Product Change Notification / SYST-24YPYI186

dsPIC33EDV64MC205 Family Silicon Errata and Data Sheet Clarification

Added silicon issue 30 (MOSFET Gate Driver).

FIGURE 1: TIMING DIAGRAMS FOR CENTER-ALIGNED AND EDGE-ALIGNED MODES

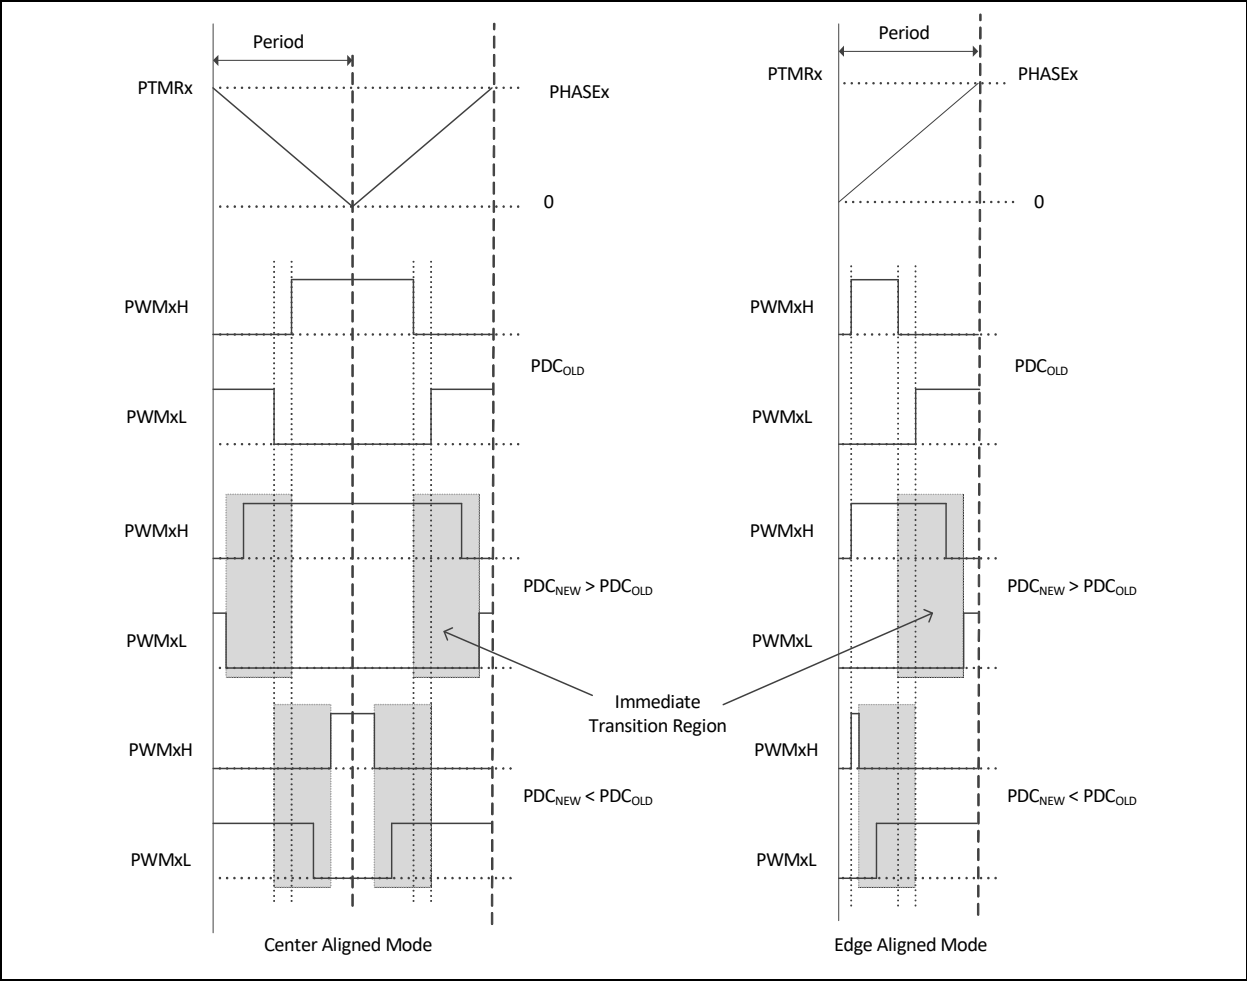
The PWM generator may not assert dead time on the edges of transitions. This has been observed when all of the following conditions are present:

The current duty cycle, PDCOLD, newly calculated duty cycle, PDCNEW and the point at which a write to the Duty Cycle register occurs within the PWM

time base will determine if the PWMxH and PWMxL outputs make an immediate transition. PWMxH and PWMxL outputs make an immediate transition if the Duty Cycle register is written with a new value, PDCNEW, at a point of time when the PWM time base is counting a value that is in between PDCNEW and PDCOLD. Additionally, writing to the Duty Cycle register, close to the instant of time where dead time is being applied, may result in a reduced dead time effective on the PWMxH and PWMxL transition edges.

In Figure 1, if the duty cycle write occurred in the shaded box, then PWMxH and PWMxL will make an immediate transition without dead time.

None.

However, in most applications the duty cycle update timing can be controlled using the TRIGx trigger, or Special Event Trigger, such that the above mentioned conditions are avoided altogether.

FIGURE 2: PWM GENERATOR TIMING DIAGRAM

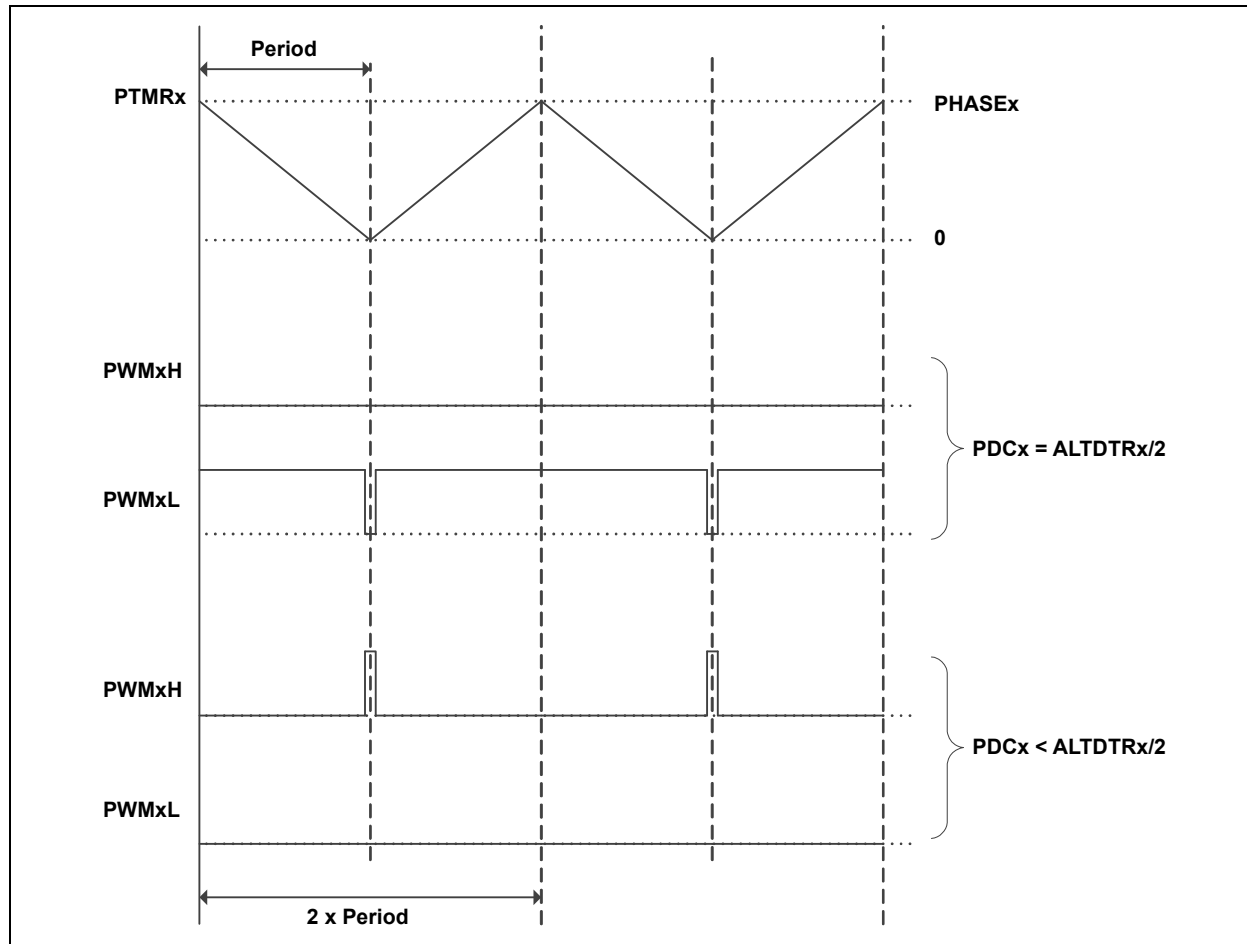
In Center-Aligned Complementary mode with Independent Time Base, if the value in the PDCx register is less than one-half the value in the ALTDTRx register, the PWM generator will force the PWMxL to low, and on the PWMxH, generate pulses of width less than twice the dead time, as shown in [Figure 2](#).

Include a software routine to ensure that the duty cycle value written to the PDCx register is always at least one-half of the value in ALTDTRx. [Example 2](#) shows one method, with PDCtemp representing the variable which has the value to be written to the PDCx register. Alternatively, for duty cycle values less than half the desired dead-time value, zero out the ALTDTRx register or dynamically reduce the value in the ALTDTRx register, such that ALTDTRx is always equal to 2 * PDCx, as shown in [Example 3](#).

FIGURE 3: ILLUSTRATION OF 1 T_{osc} GLITCH WHEN PWM OVERRIDE IS TURNED OFF

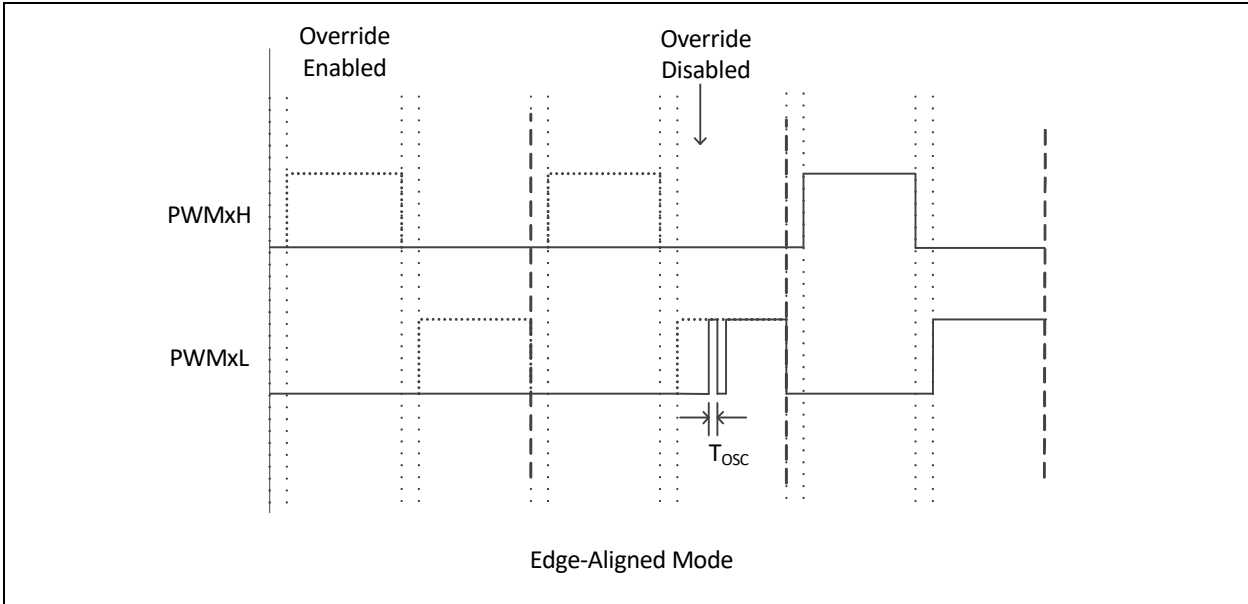
In Complementary mode after the PWMx module is enabled (PTEN = 1), if the PWM override is turned off, a 1 T_{osc} glitch will be present on the rising edge of either PWMxH or PWMxL, whichever occurs first, as shown in Figure 3. The glitch will be present on PWMxH/PWMxL every time the override state is changed from enabled to disabled. The width of this glitch is equal to 1 T_{osc} when PCLKDIV[2:0] = 000; increasing the PWM input clock prescaler setting will increase the width of the glitch accordingly.

Since the width of the glitch is just 1 T_{osc} at higher values of F_{osc}, the glitch may not be visible on the PWMxH/PWMxL pins due to pin and PCB trace capacitances.

None.

FIGURE 4:

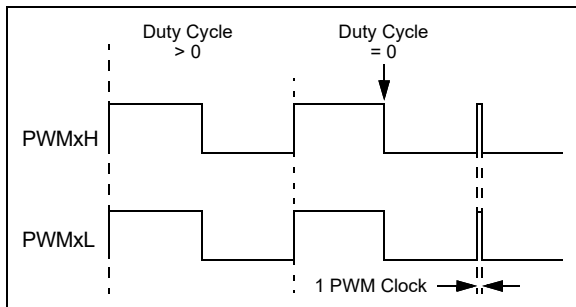
In certain output modes, the PWMx module produces a pulse glitch of one PWM clock in width (Figure 4). This has been observed only when all of the following are true:

- Either Redundant or Push-Pull Output mode is selected (IOCONx[11:10] = 10 or 01);
- Immediate Update is disabled (PWMCONx[0] = 0); and
- The value of the current Duty Cycle register (either the PDCx or MDC register, as determined by PWMCONx[8]) is updated to zero from any non-zero value.

The pulse glitch has been observed to occur at the beginning of the following PWM boundary period.

If the application requires a duty cycle of zero, two possible work arounds are available.

1. Use the PWM overrides to force the output to a low state instead of writing a '0' to the Duty Cycle register. When using this method, the PWM override must be disabled when the duty cycle is a non-zero value. If output override synchronization is configured to occur on CPU clock boundaries (IOCONx[0] = 0), enabling and disabling the override must be timed to occur as closely as possible to the PWM period boundary.
2. Configure the module for Immediate Update (PWMCONx[0] = 1) *before* enabling the module. In this mode, writes to the Duty Cycle register have an immediate effect on the output. As with the previous work around, writes to the Duty Cycle register must be timed to occur as close to the PWM period boundary as possible in order to avoid distortion of the output.

FIGURE 5:

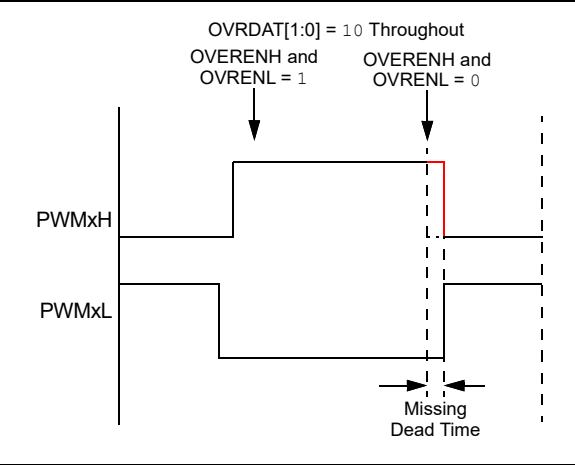
In Complementary Output mode, the expected dead time between transitions of the PWMxH and PWMxL outputs may not be asserted when the following occurs:

- Output override synchronization is configured to occur on the CPU clock boundary (IOCONx[0] = 0);
- Both PWMxH and PWMxL overrides are enabled prior to the event (OVRENH and OVRENL are both '1'); and
- Both overrides are disabled (OVRENH and OVRENL are both '0') at the instant the dead time should be asserted (Figure 5).

This has been observed in both Center-Aligned and Edge-Aligned modes.

None.

FIGURE 6:

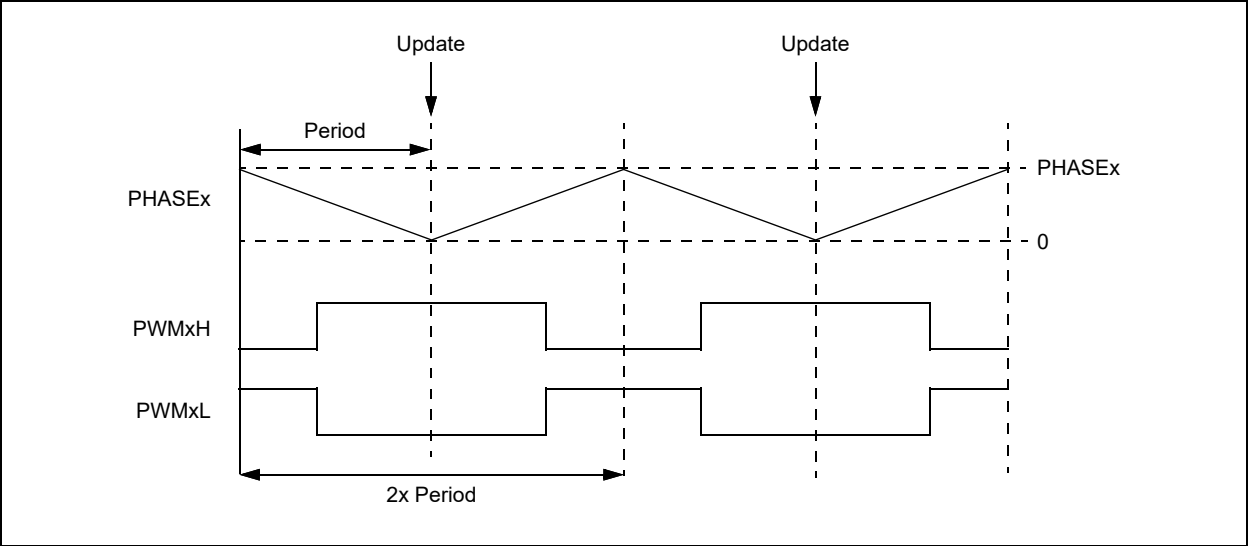
In Center-Aligned Complementary mode with Independent Time Base, updates to the PHASEx register take effect in the middle of a center-aligned PWM cycle, as shown in Figure 6. This occurs only when the Immediate Update feature is disabled (IUE = 0). If Immediate Update is enabled (IUE = 1), the PHASEx register updates will take effect immediately.

None.
